First Street South - Manchester

10266-SHP-RP-PA-014 | Planning Amendment NMA-05 | 04 OCTOBER 2023

The drawings are comparing the ‘approved’ and ‘revised’ drawings to document the changes made following further discussions with the operator.

Z1 - Ground Floor Plan Revisions

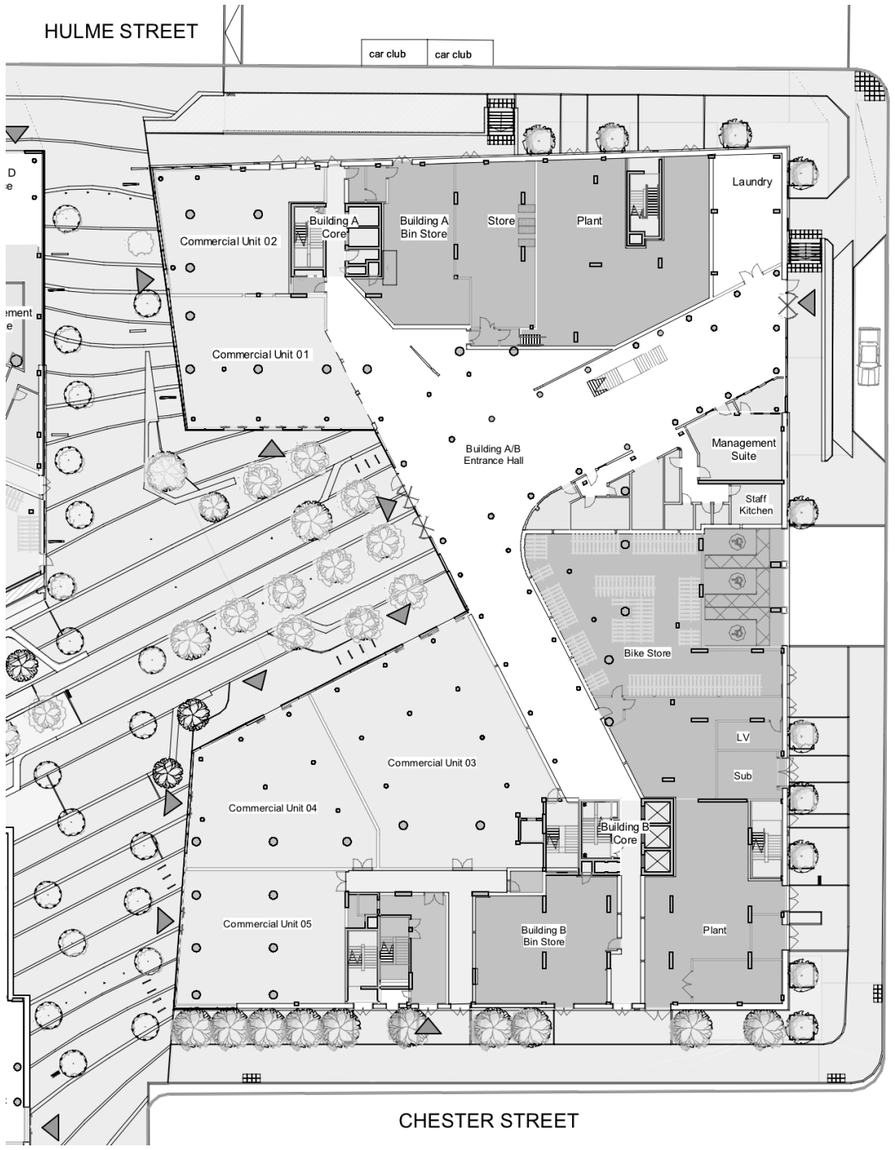
2.

Introduction of Delivery Hub Door on Wilmott Street

3.

Adjustment to doors and windows following design development

4.

Landscape adjusted in line with the above
